Addendum No.1

Project: Audie Murphy Hospital - Replace HVAC Units - Phase IV

Issuance Date: June 13, 2014

Item No. 1 Sheet M-103 - BASEMENT PIPE SPACE DEMO PIPING PLAN

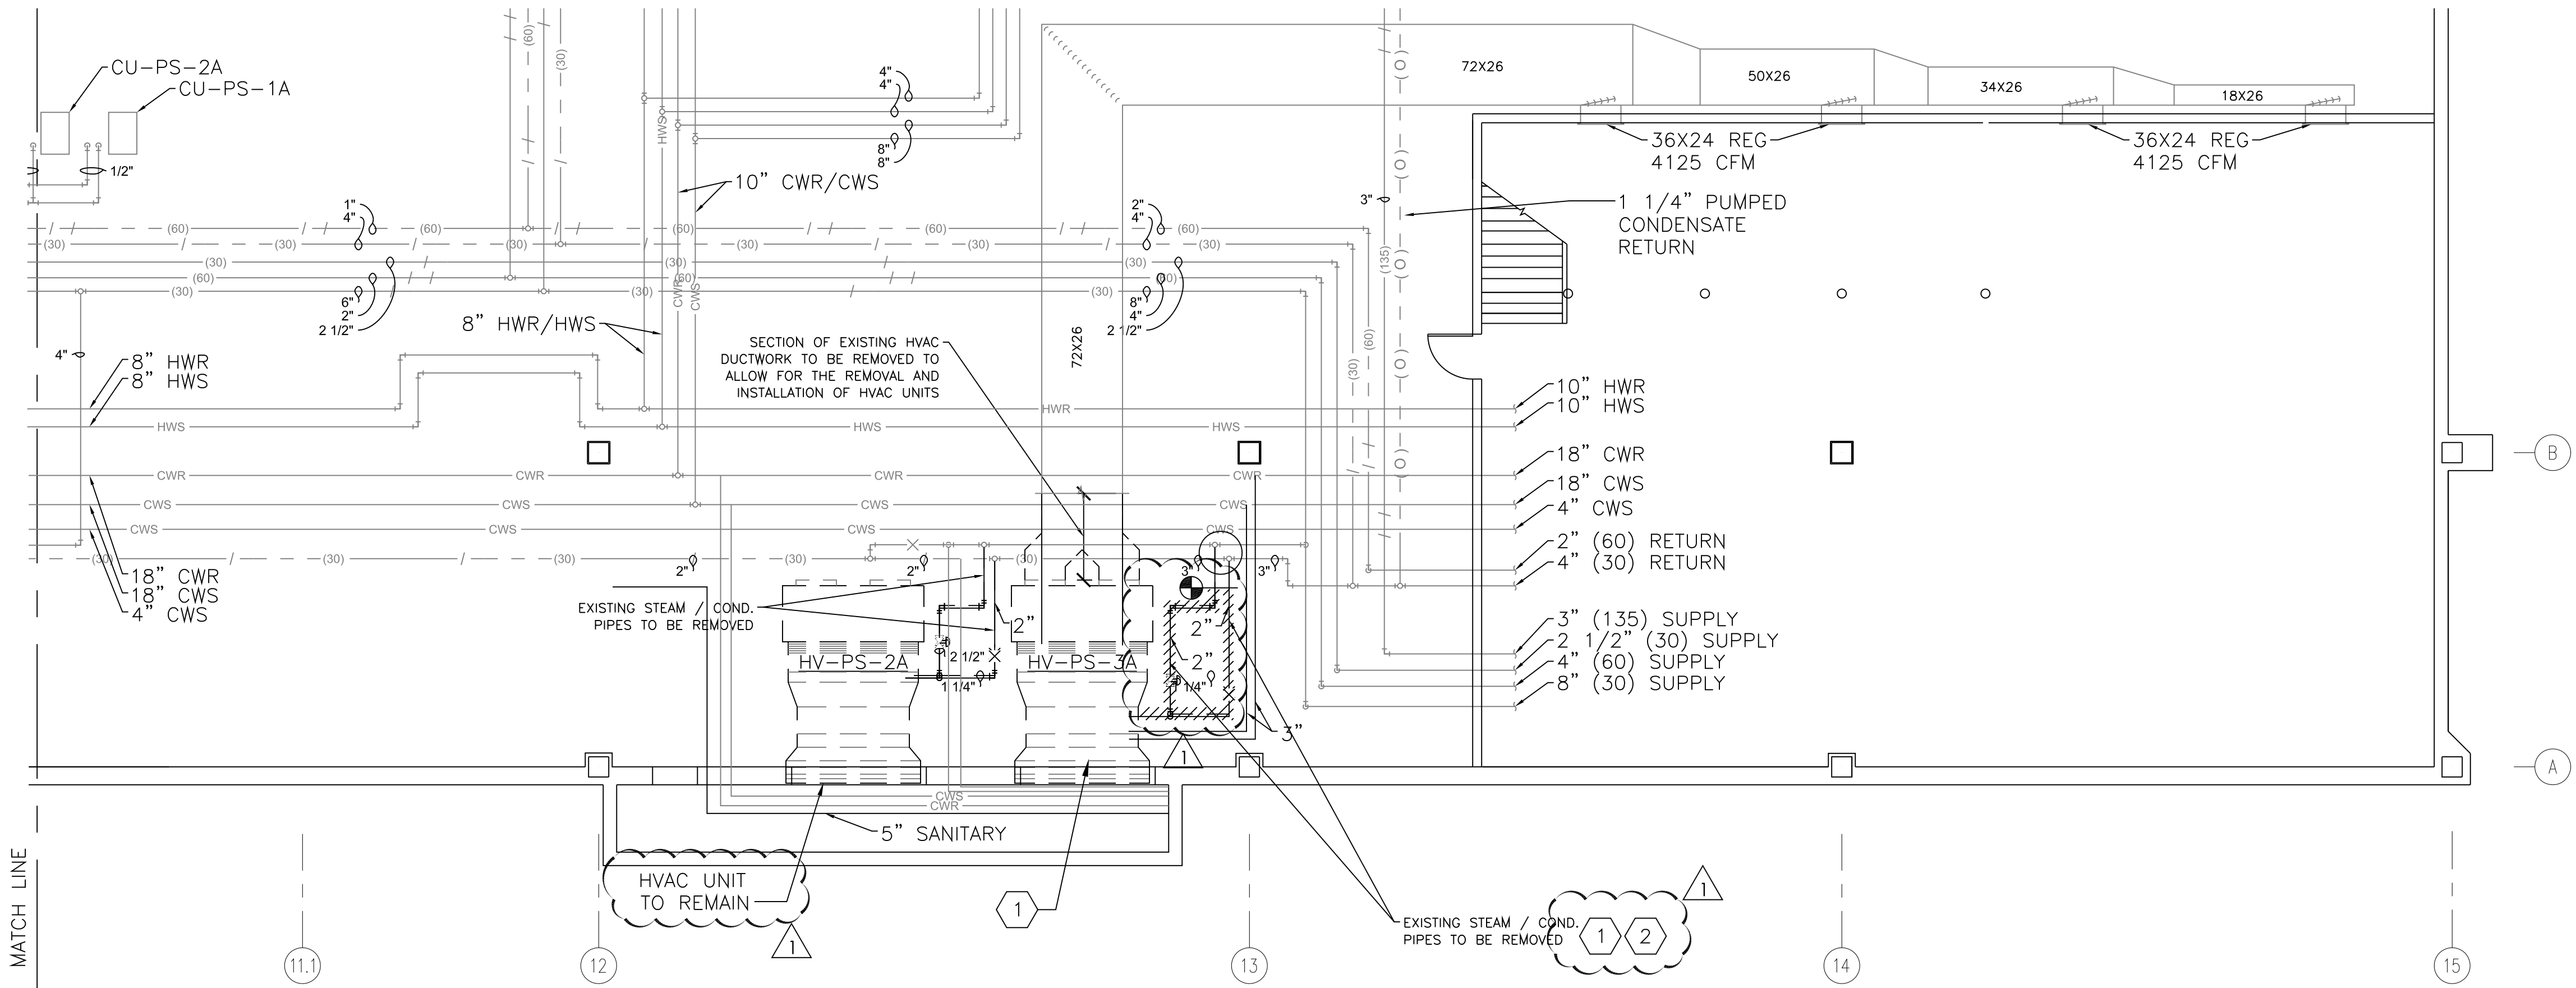
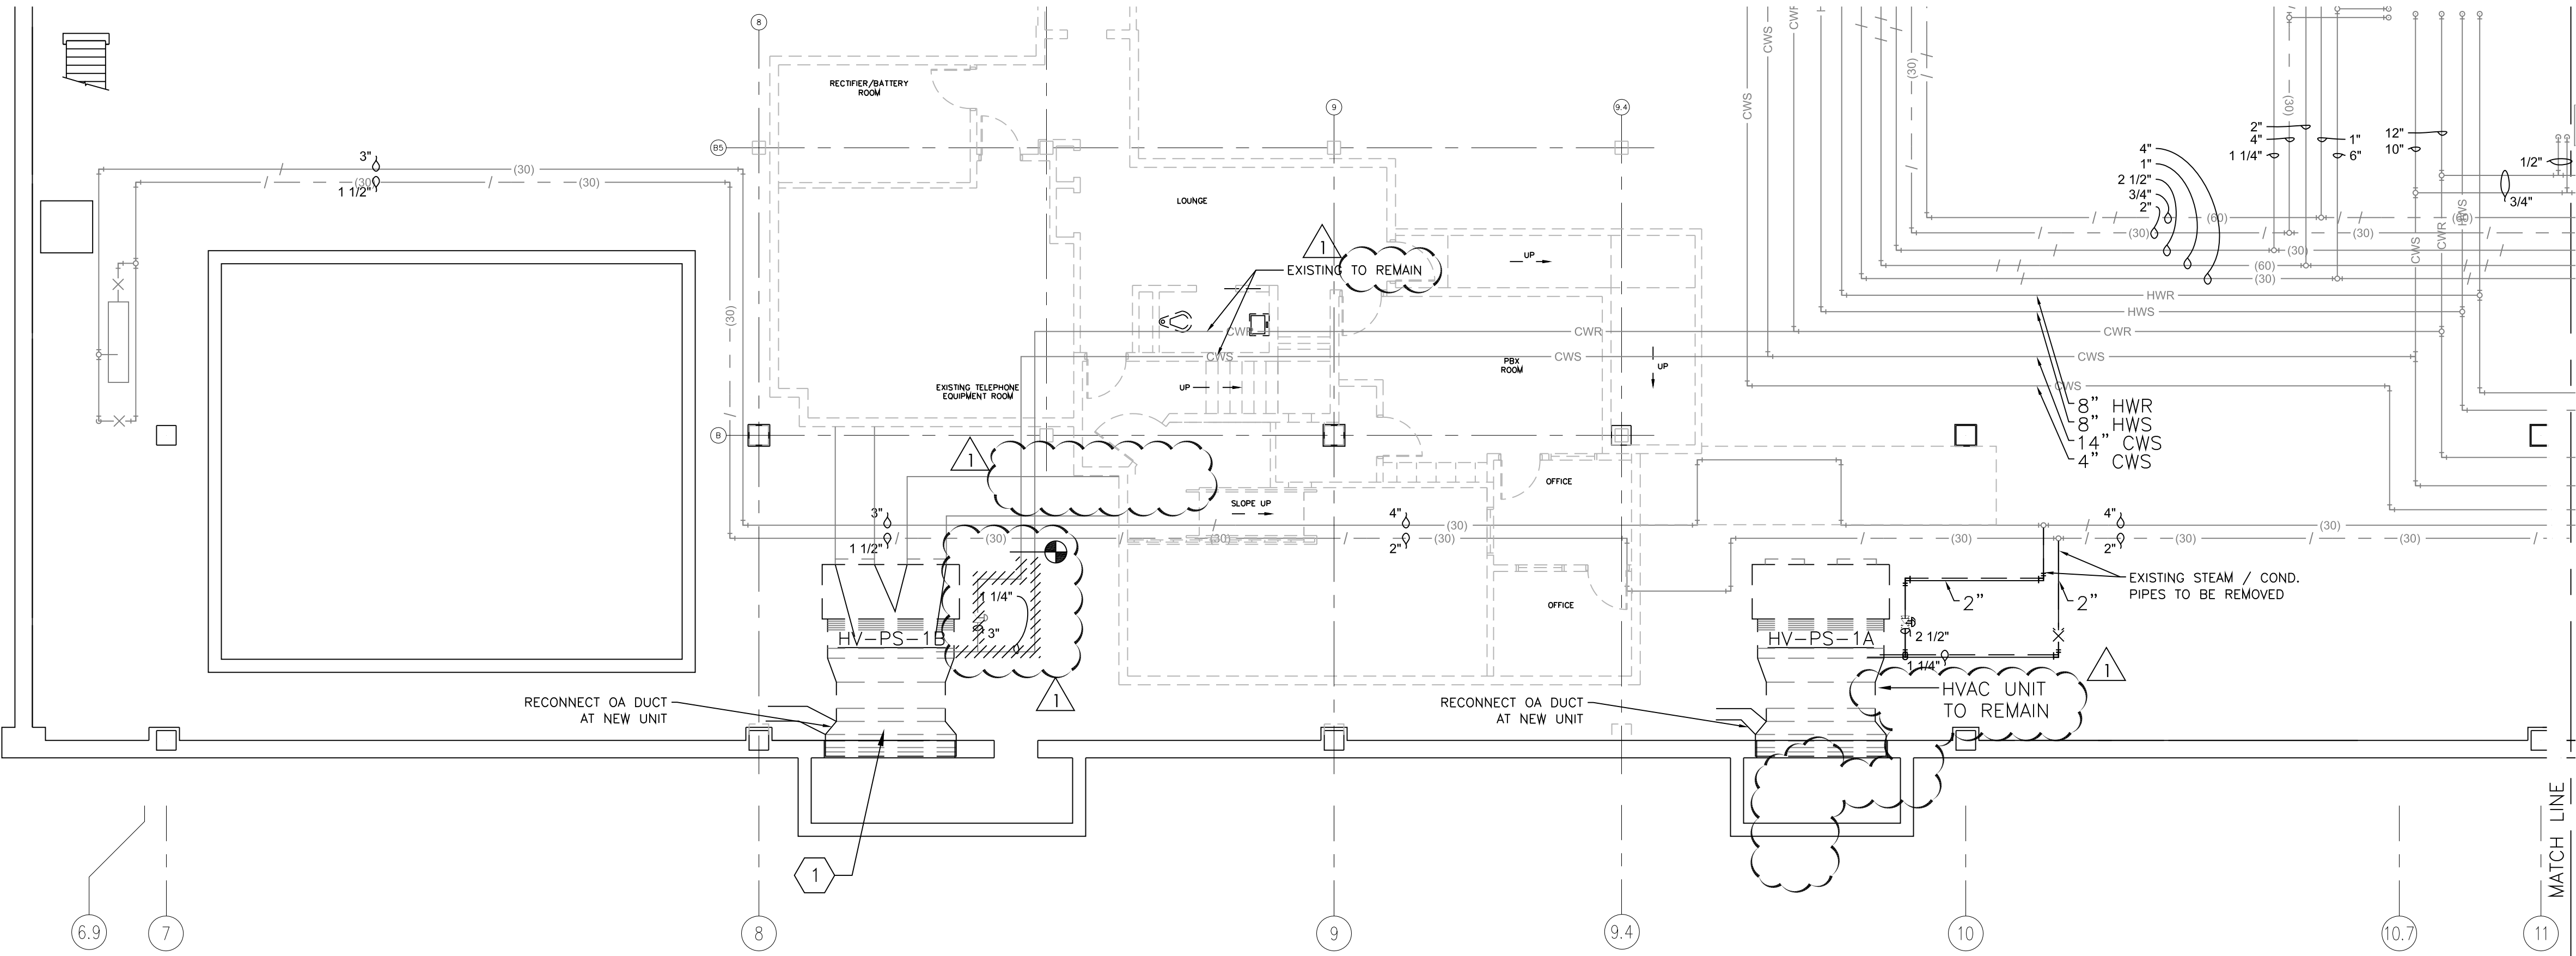
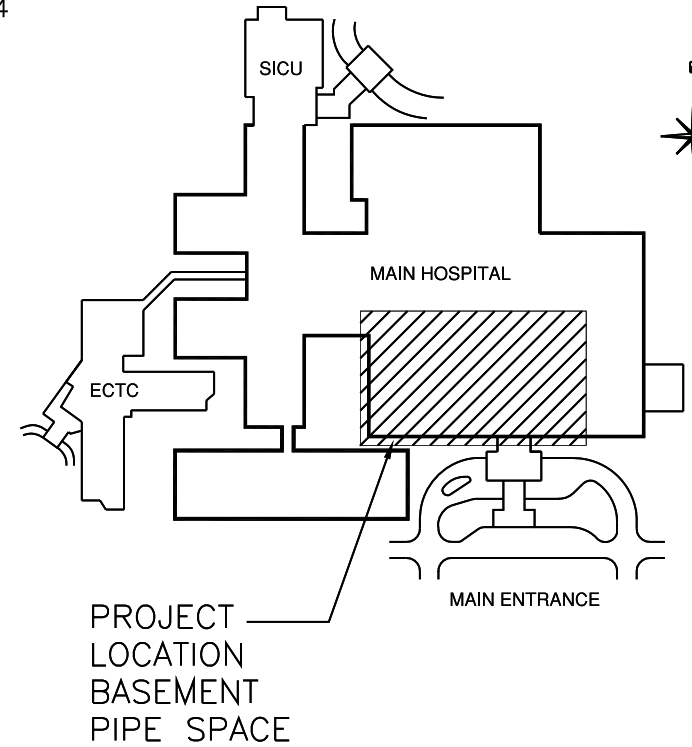
1. The Contractor shall demolish items as shown on the attached drawing.
